Interactive comment on “Optimal Output Feedback H_∞ Torque Control of a Wind Turbine Rotor using a Parametrically Scheduled Model” by Dana Martin et al.

Response to referee 1 comments Thank you to the reviewers and editors for the comments and the opportunity to revise and improve our paper. We have made substantial revisions to the paper to address the comments from both reviewers. In this document, we explain how we addressed specific comments in our revision.

Fig. 1. Figure 1

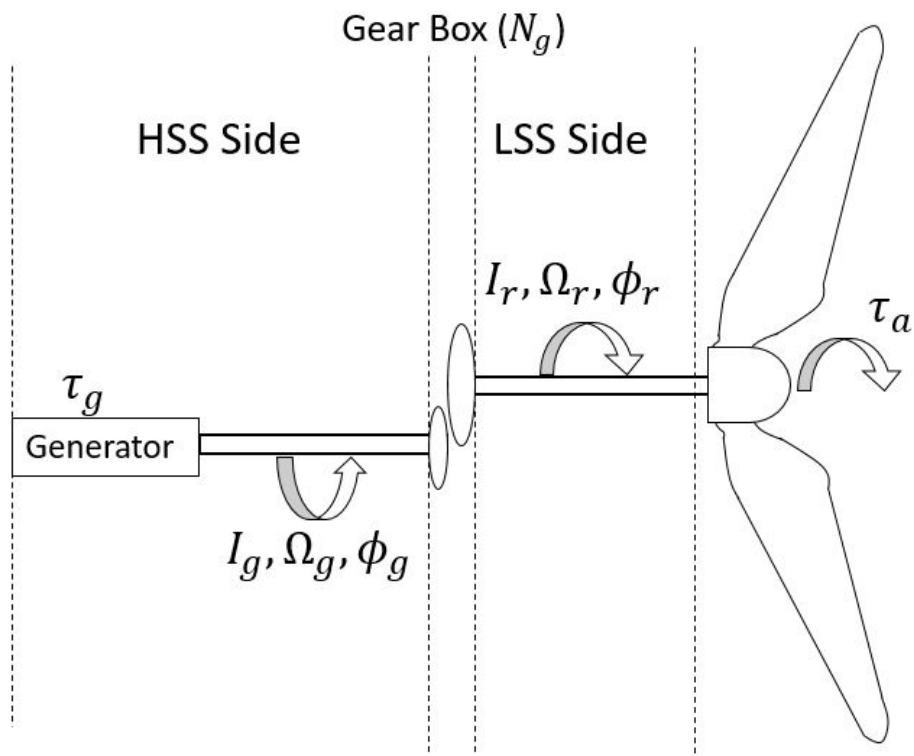
a novel rotor design concept which aims to utilize morphing rotor technology in order to accomplish load alignment (Loth et al., 2017) such that structural design requirements are reduced. The SUMR-D design is a scaled version of the SUMR-13i design (Ananda et al., 2018), which will be used to validate the design process as a proof of concept field prototype. Specific details of the turbine model we use in the research follow in Section 3. While the application of the controller will be applied to the down-wind, two bladed SUMR-D rotor, the modeling and controller synthesis procedure is valid for any VSVP wind turbine model.” (pg. 5) Which wind turbine (model) do you use in this paper? The wind turbine model has been introduced in Section 2.2 (pg. 5) as given in response 1i above. Furthermore, Section 3.1 gives further details of the SUMR-D rotor, see below for text. “Controller performance evaluation was conducted as applied to the Segmented Ultra-light Morphing Rotor – Demonstrator (SUMR-D). This rotor is a Gravo-Aeroelastically Scaled (GAS) model (Loth et al., 2018; Kaminski et al., 2018) of the 100- meter blade SUMR-13i (Ananda et al., 2018; Martin et al., 2017; Martin and Zalkind, 2016; Zalkind et al., 2017) down-wind, two-bladed rotor with a pre-aligned rotor (Loth et al., 2017). This scaling method aims to fully capture the key dynamics of the full-scale model with an emphasis on matching the non-dimensional flapping frequency, moment ratios, flapping tip deflection and design tip speed ratio as represented by values given in Table 2.” (pg. 18) Why do you use different symbols (Q_a and τ_g) for torques? Also Q_{xx} and τ are not indicated in Figure 1. Q_a has been changed to τ_a and is used to denote the aerodynamic torque generated by the wind exerted on the rotor, while τ_g is used to denote the electrical torque applied by the generator on the high speed shaft. The variables have been updated and included in Figure 1. Additionally, state-space system has been updated as seen in Figure 4 below.

Maybe introduce a new symbol for ϕ_r - ϕ_g A new symbol of $\Delta\tilde{\Gamma}$ denoting the difference between the azimuthal positions has been included. How do you obtain the aerodynamic torque gradients? From data of a real wind turbine? The aerodynamic torque gradients are obtained through FASTv8 linearization and an optimal tip speed ratio λ_{opt} tracking trajectory. This has been made clearer through the explanation on (pg. 7) as

Fig. 2. Figure 6a

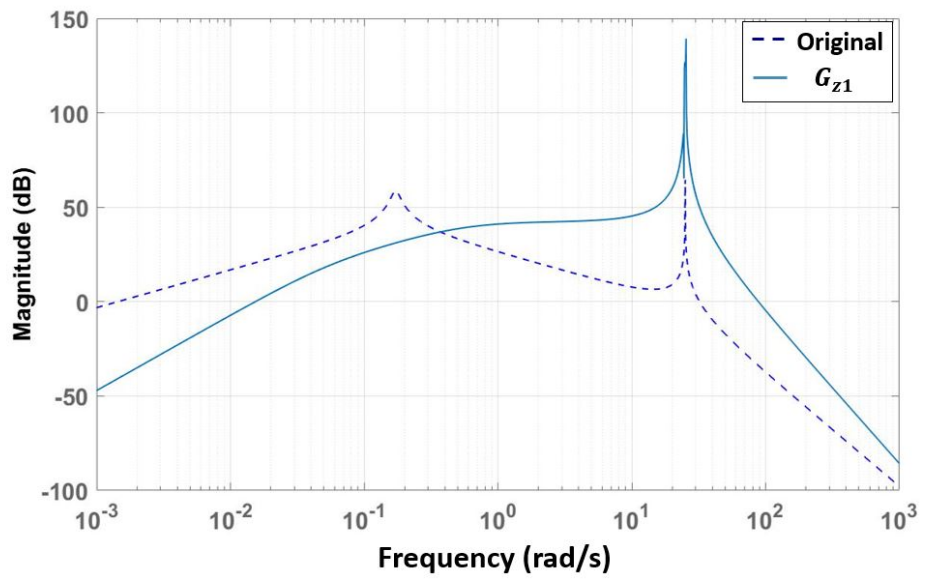
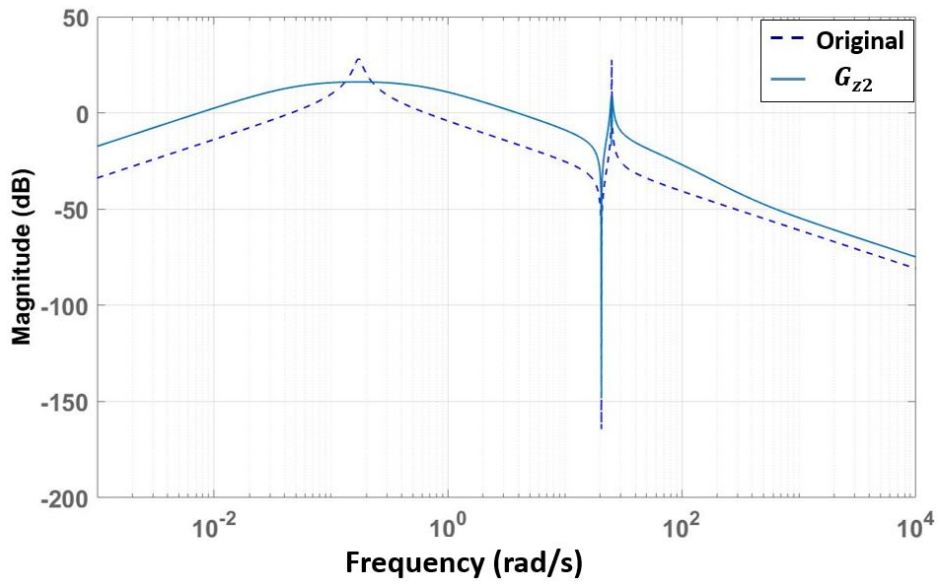
achieving such responses as depicted in Figure 6.” (pg. 12) See Figures 2 and 3 below
Complete paragraph "The loop shaping ... and step response", should be revised. I
don't understand what's going on here. This has been further clarified as presented in
response 5ii. (pg. 12)
